UNITED STATES PATENT AND TRADEMARK OFFICE

10/696,208

Office Action Summary	Application No. 10/696,208	Applicant(s) WALTON ET AL.	
	Examiner WILLIAM D. CUMMING	Art Unit 2617

DETAILED ACTION

FIG. 12

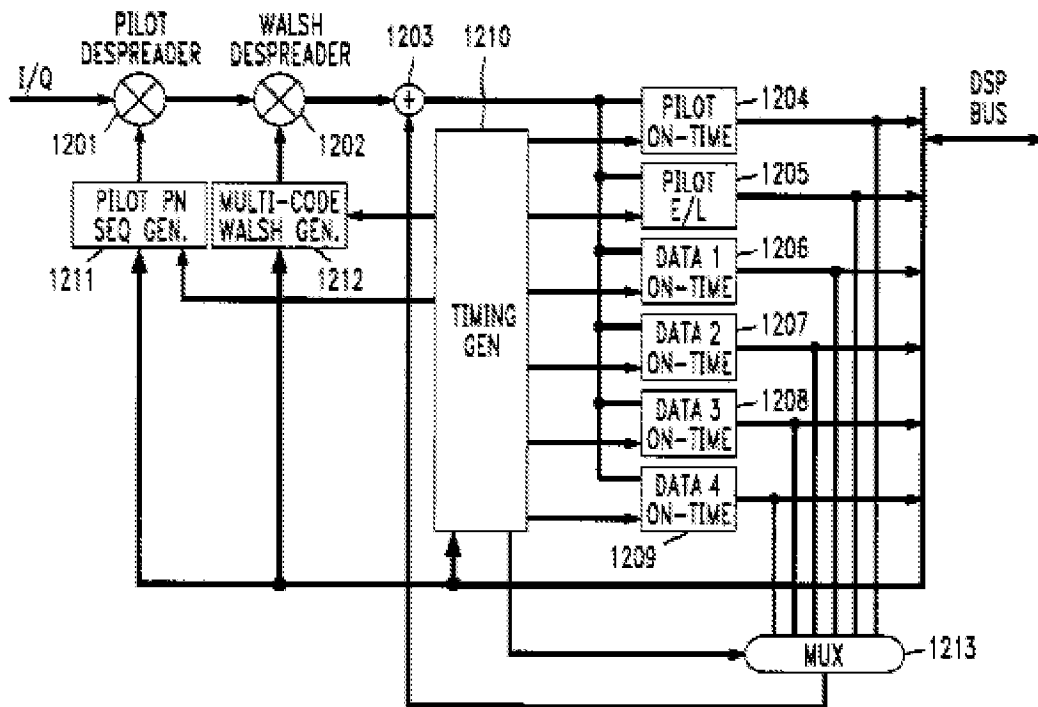
12. Claims 1, 2, 5-8, 12, 13, 15-21, 23-25, 27, 28, and 30 are rejected under 35 U.S.C. 103(a) as being unpatentable over **Huang, et al** in view of **Fasel** as stated in paragraph 3 of the Office action dated October 3, 2008.
